**ADDENDUM #1**  
INVITATION FOR BID #25-29

**IMPROVEMENTS TO ALBEMARLE PLAYGROUND PHASE I**

**ADDENDUM NO. 1**

**IFB #25-29**

**L205**

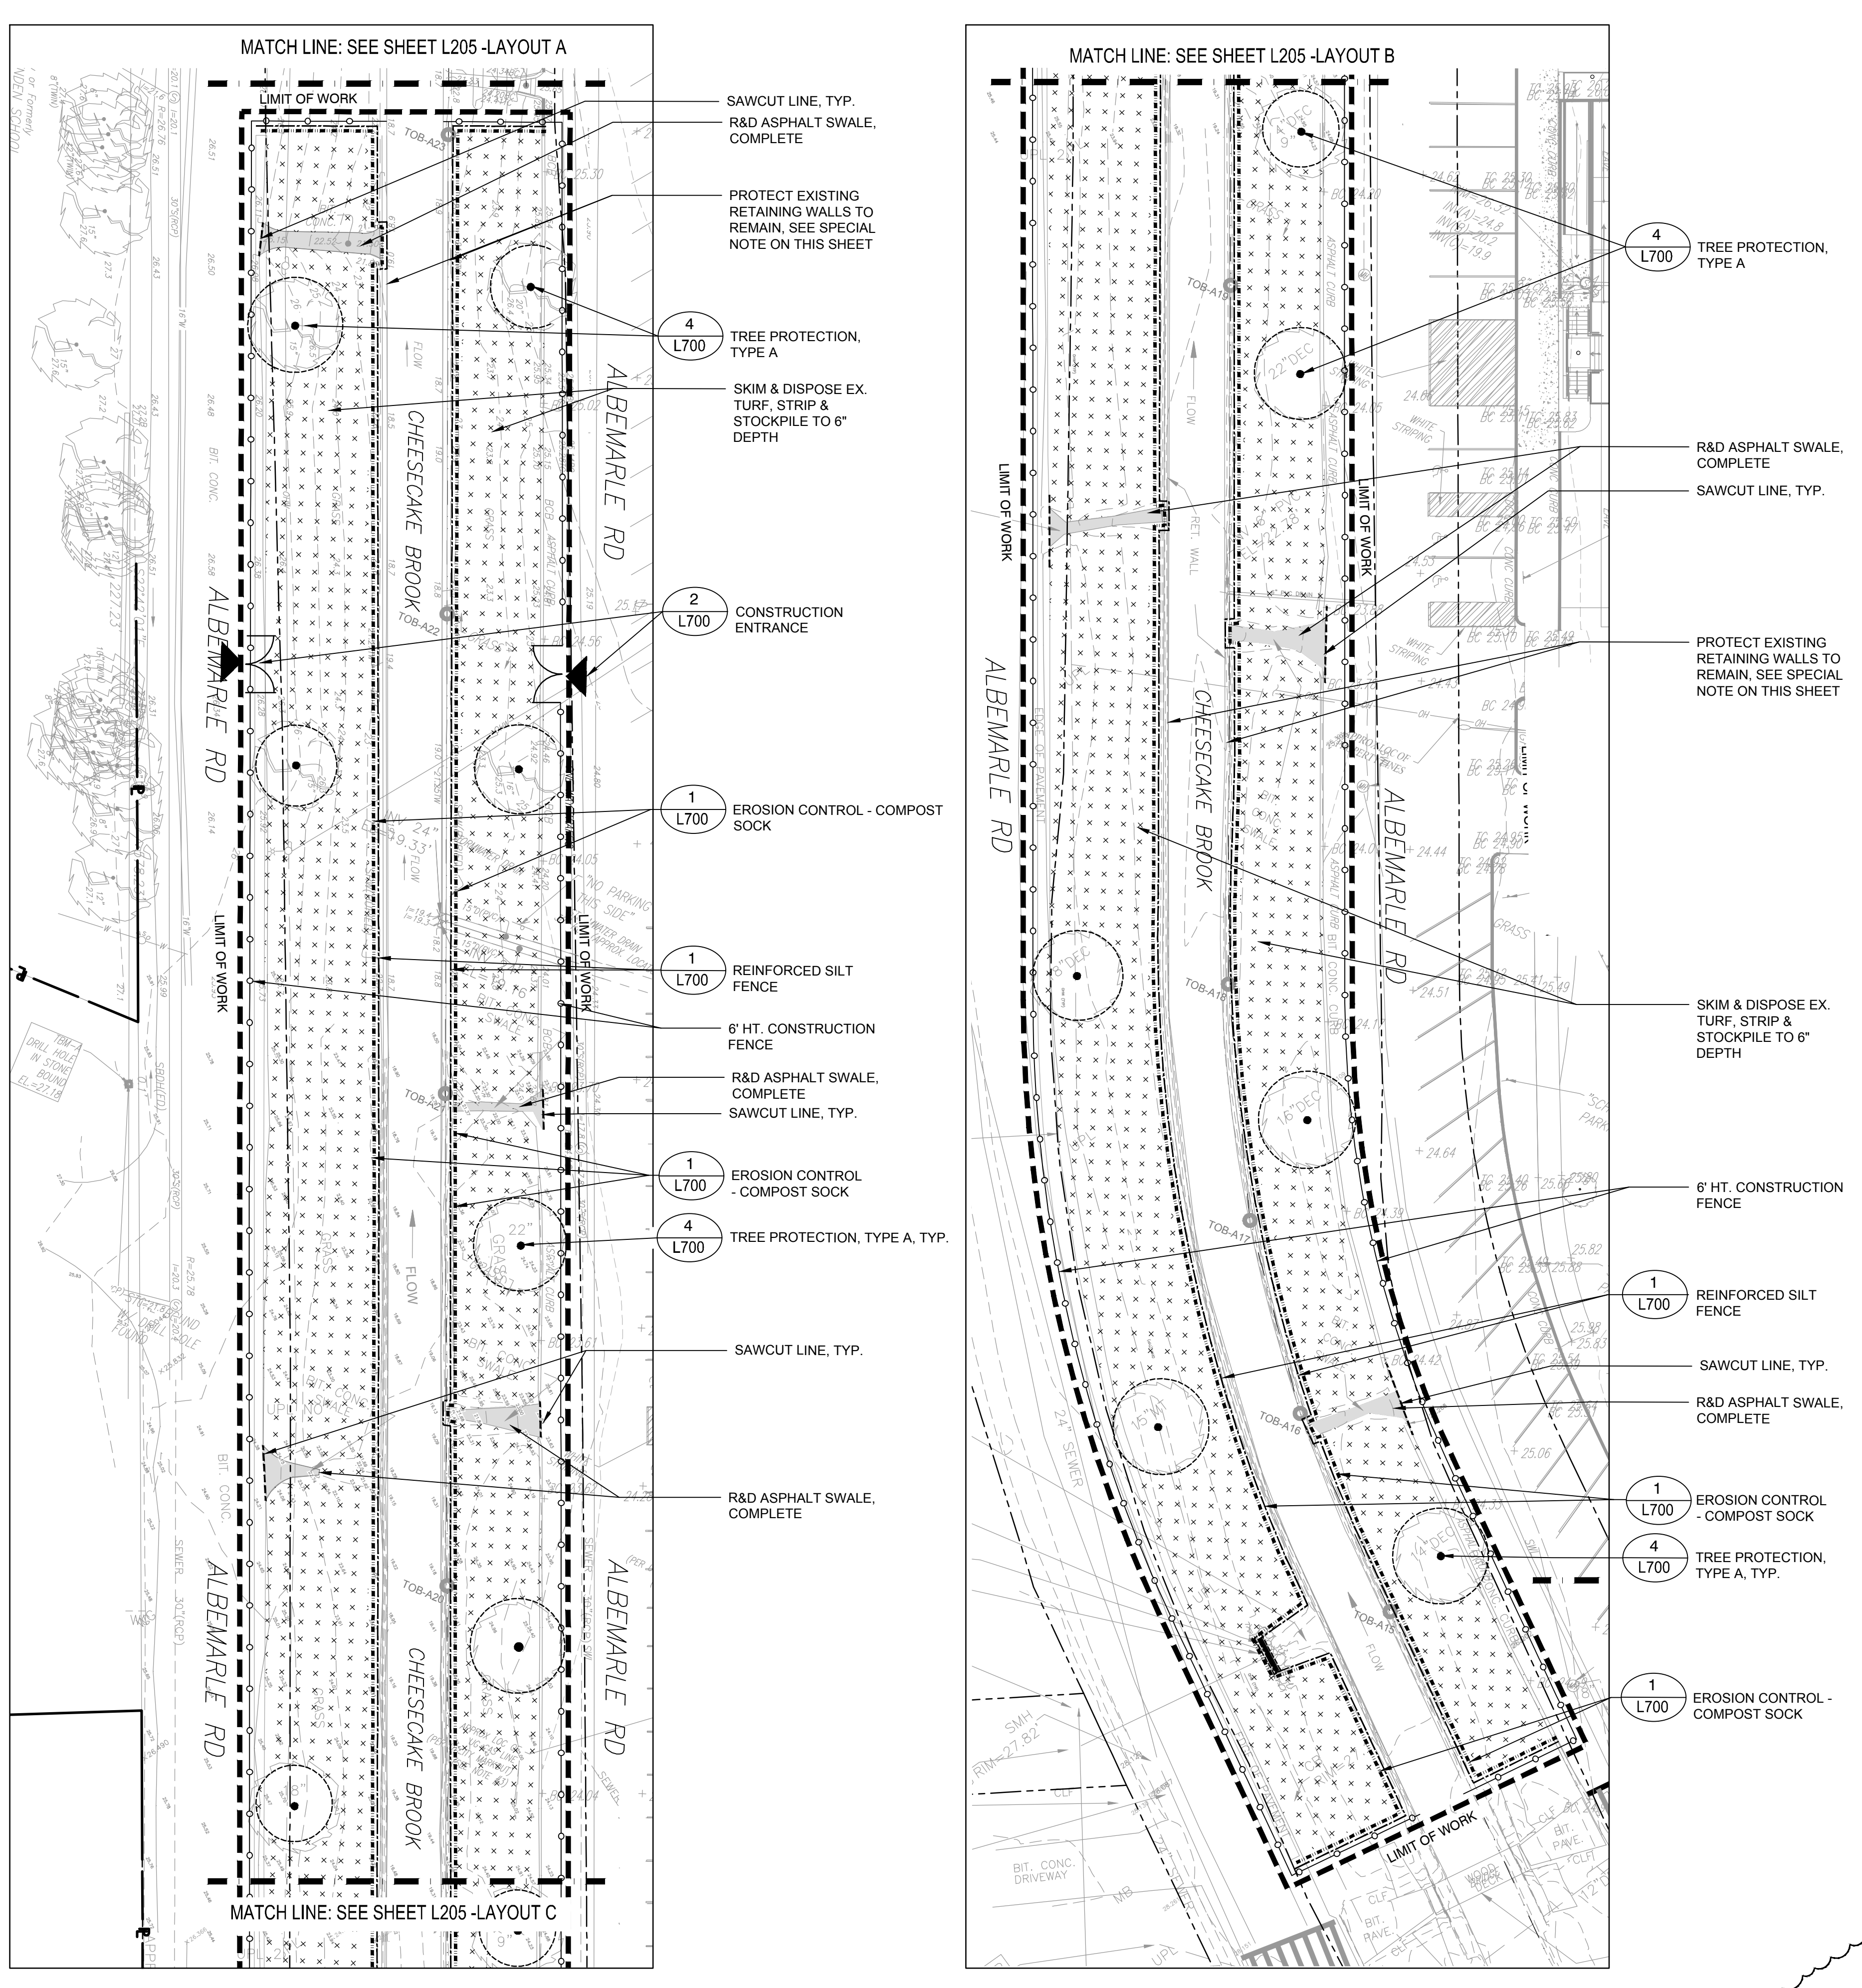
1. The sign-in sheet for the October 31<sup>st</sup>, 2024 Prebid meeting has been included as an attachment to this addendum.
2. The curbing at the mitigation area along Cheesecake Brook shall be removed from the project scope aside from approximately 36 LF, which shall be furnished by Owner and installed by the Contractor. See the revised sheets L205 and L305 in the attachments to this addendum.

**L302**

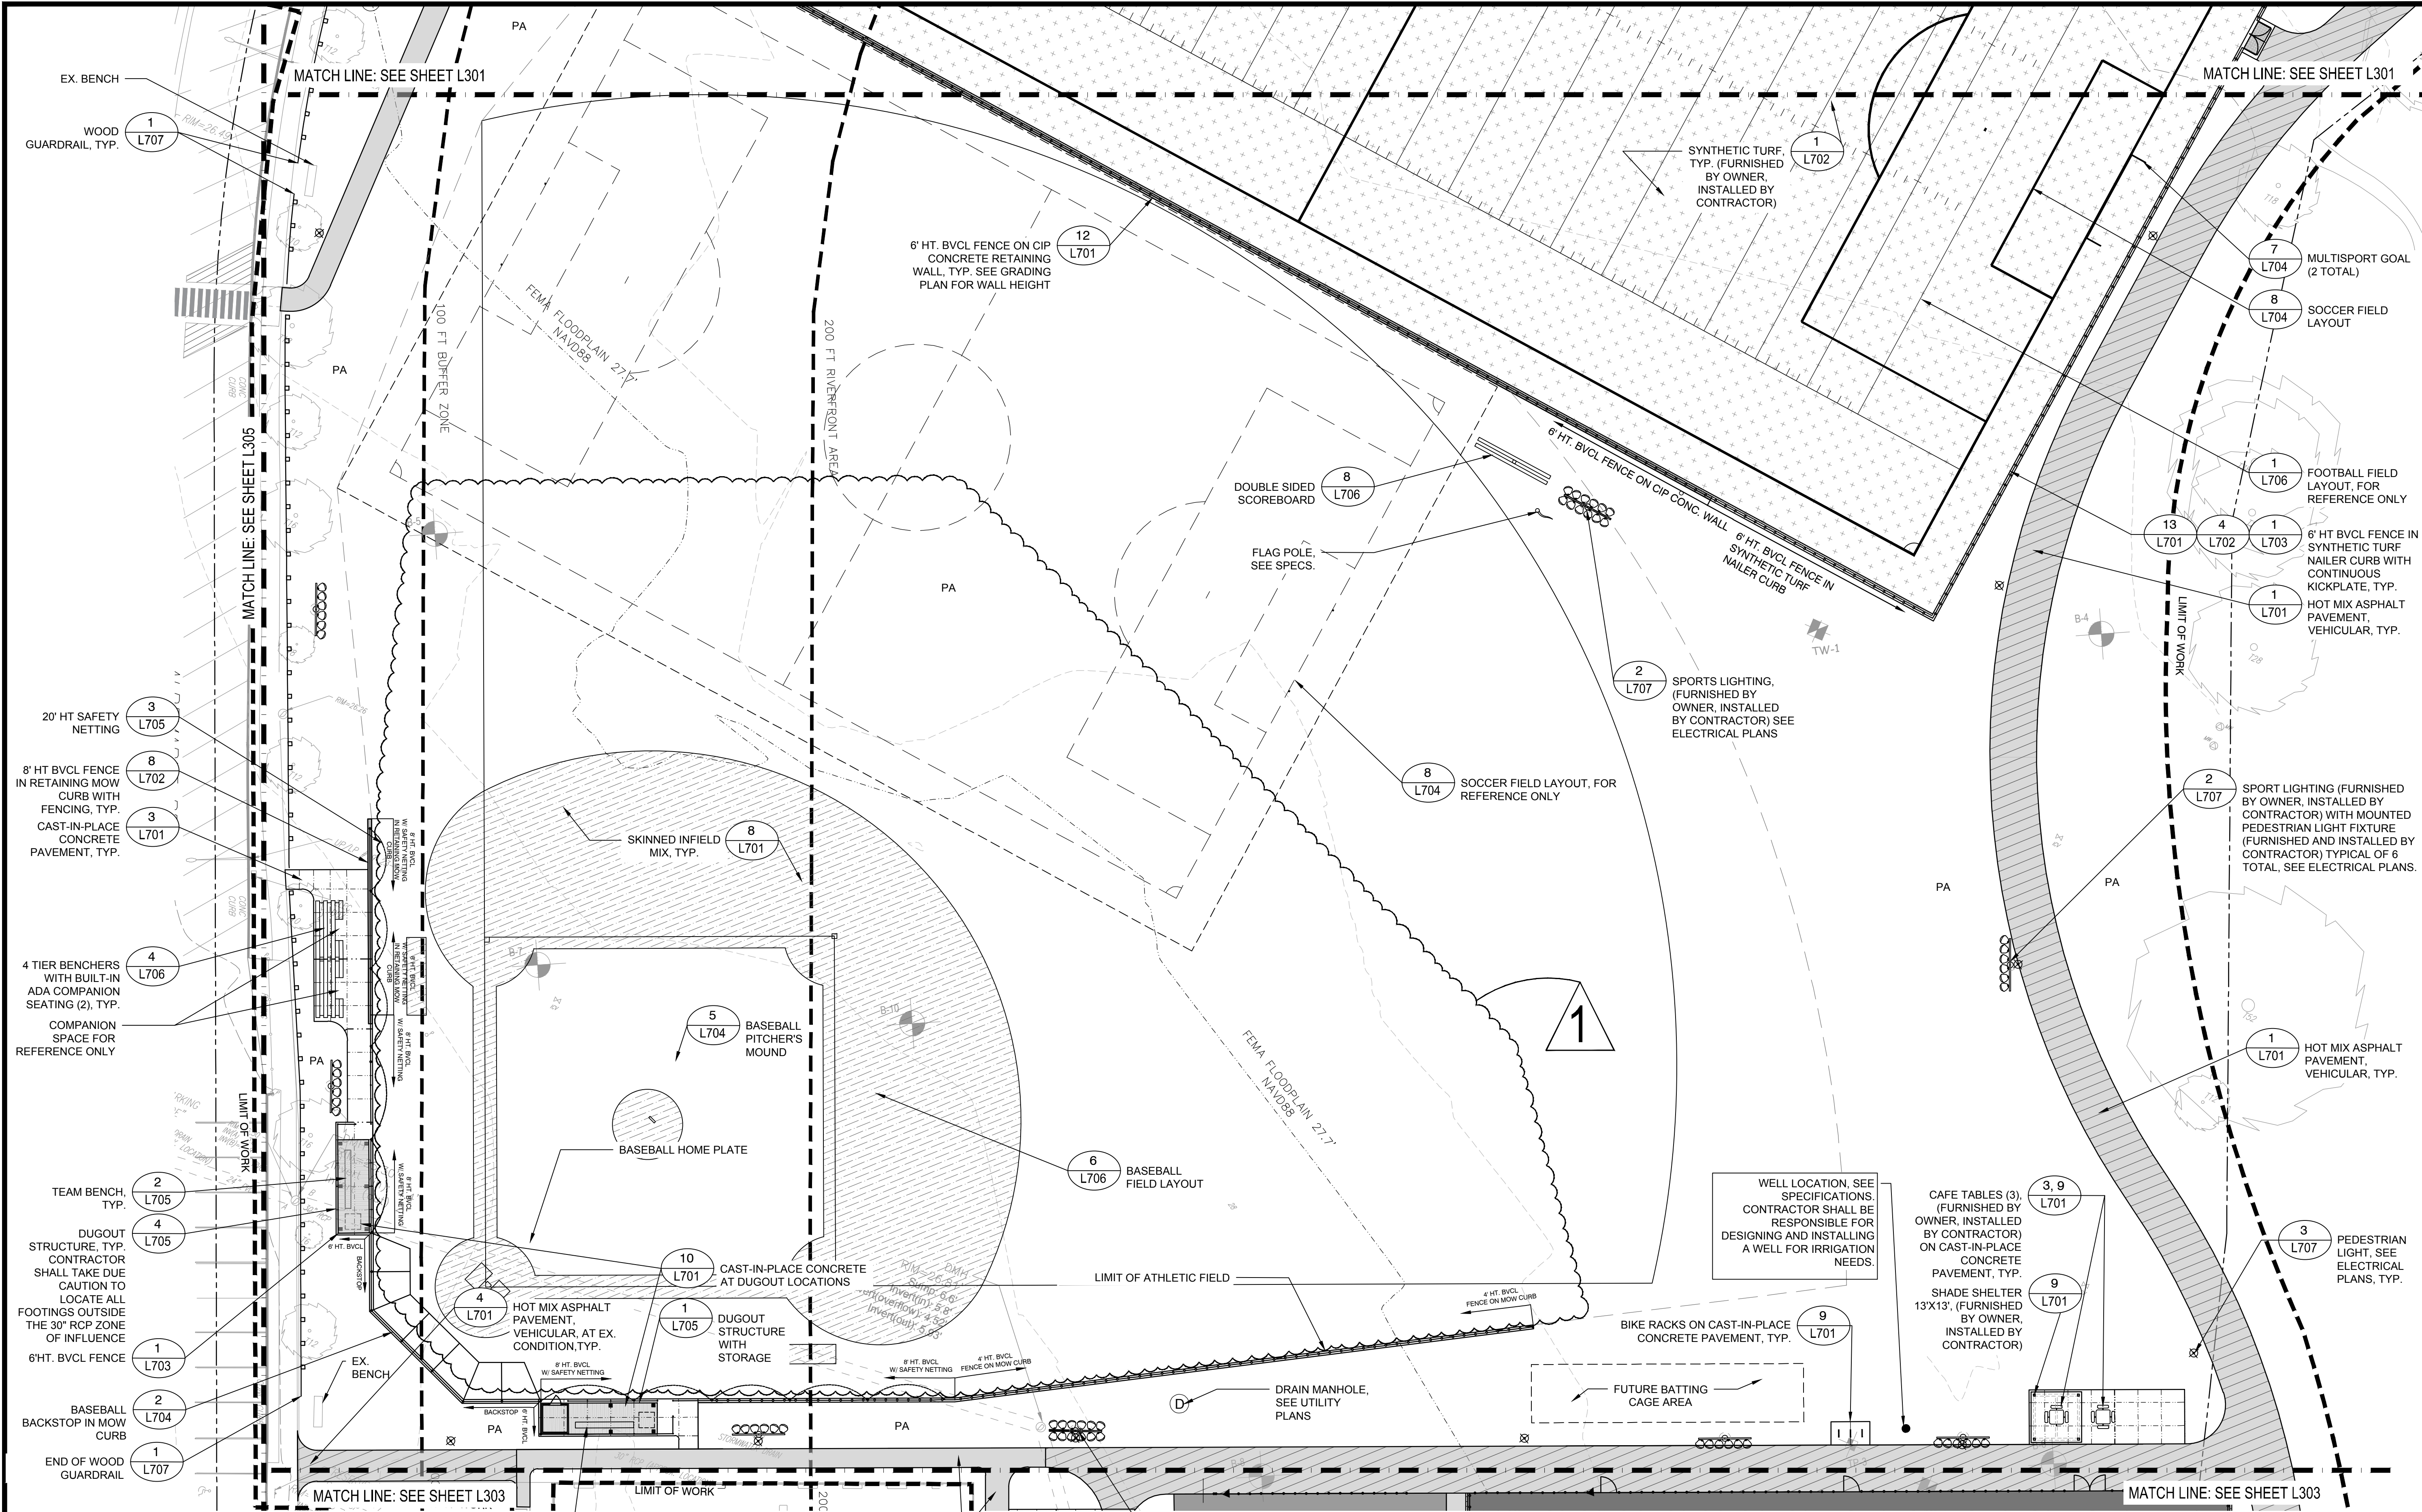
3. The baseball infield shifted 15’ closer to the backstop, placing home plate exactly 25’ from the backstop fencing. This shift ensures the center outfield is approximately 330’ from home plate. See the revised sheets L302, L402, L501 and L502 in the attachments to this addendum.

Sheet Number:  
**E302**

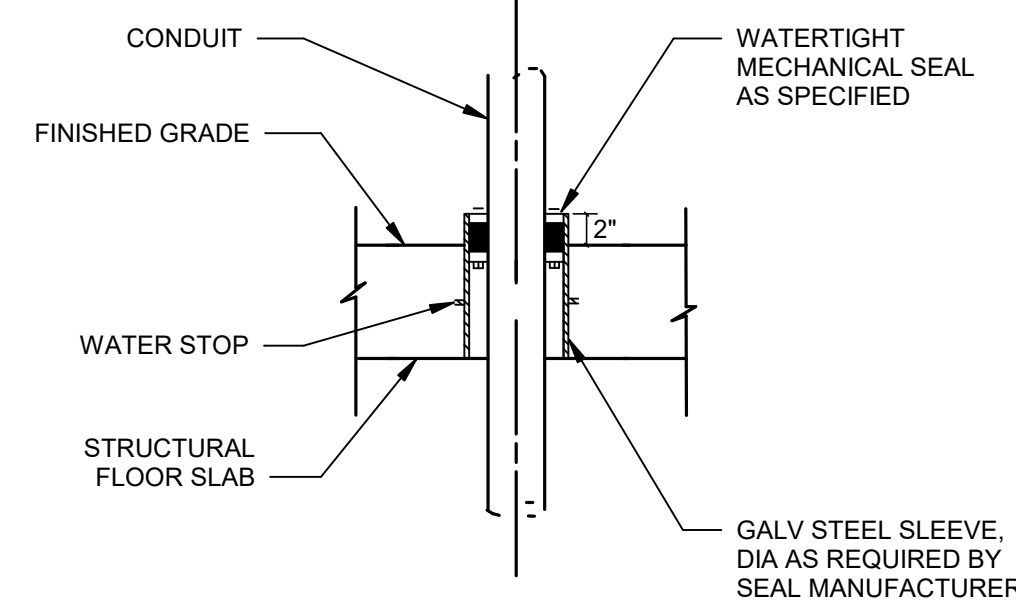
4. All chain link fence gate latches shall be 42” from finished grade.
5. The baseball field and turf field double scoreboard shall be solar powered. See the revised electrical sheet E302 in the attachments to this addendum.

1

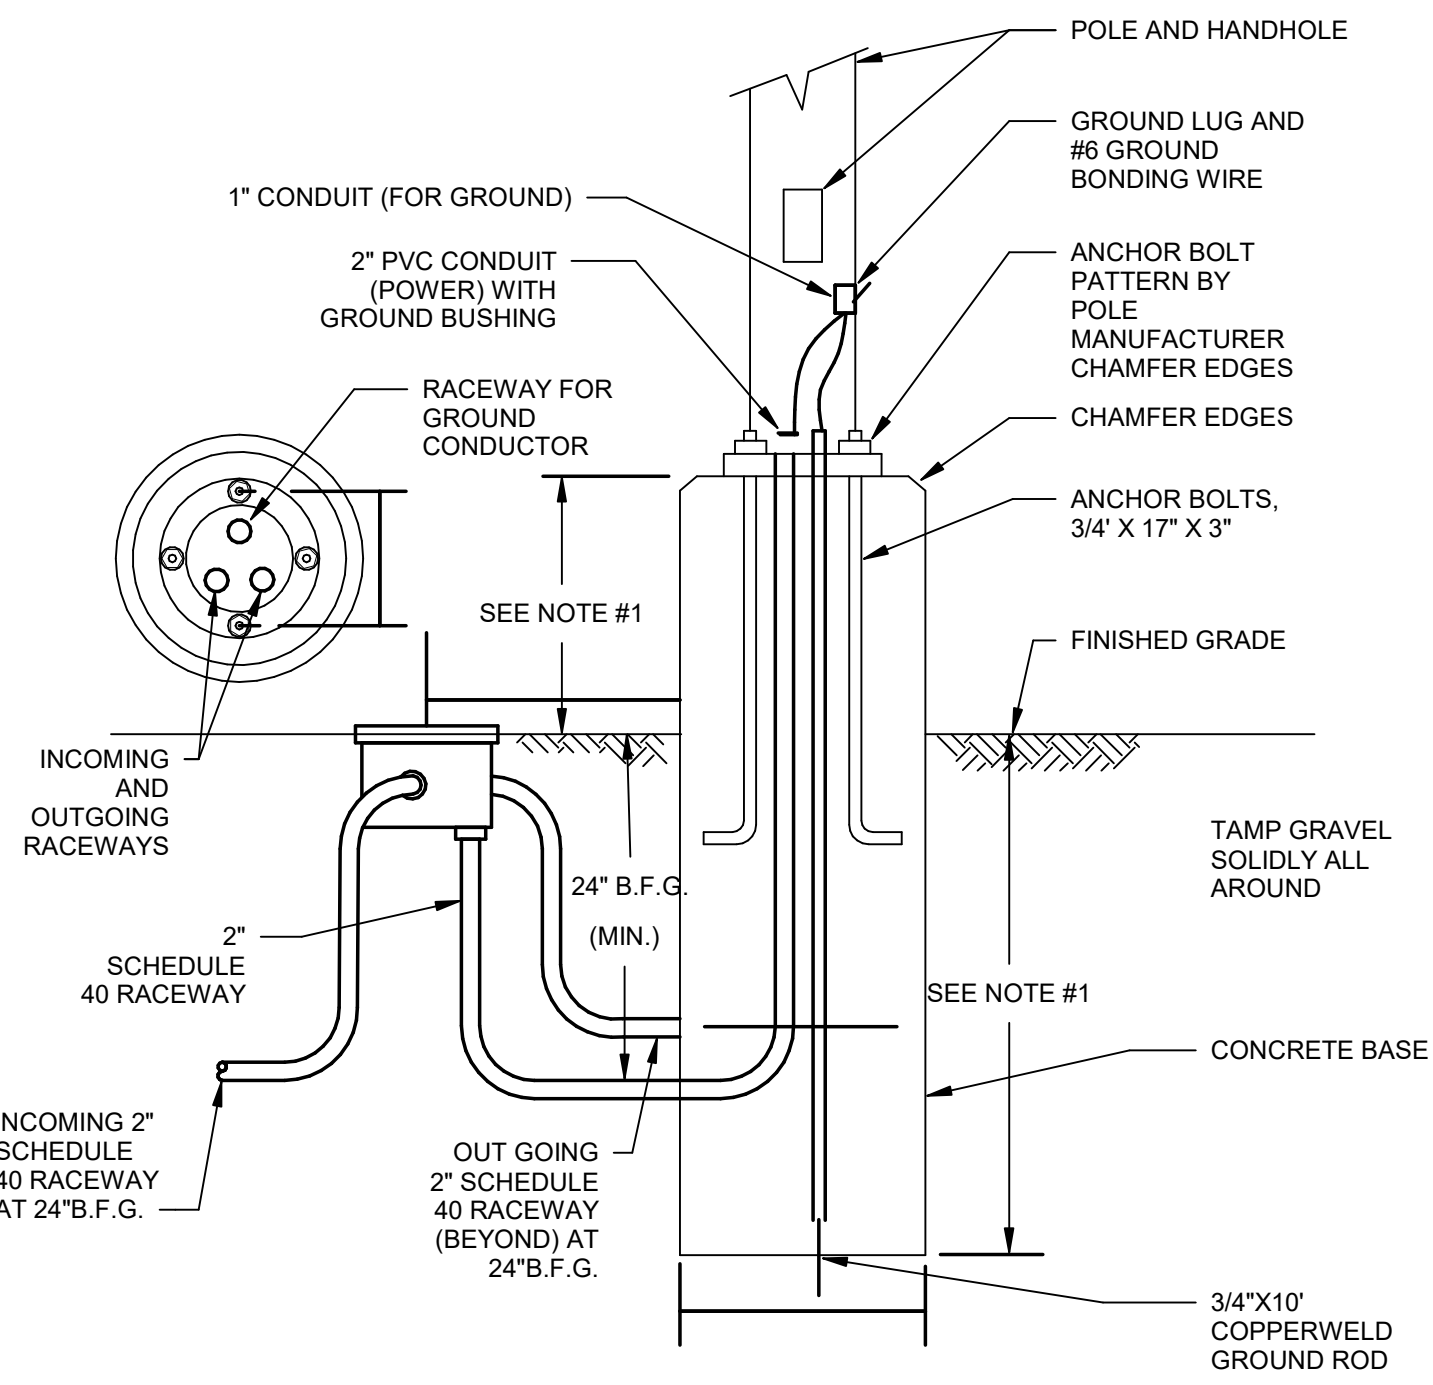
6. The electrical wall penetration at the existing building has been clarified with an added detail. See detail 6 on the revised sheet E900 in the attachments to this addendum.
7. Detail 1 on sheet L705 has been revised and included along with cut sheets on the dugout shelter with (and without) the storage unit as an attachment to this addendum.
8. Groundwater test results have been included as an attachment to this addendum.
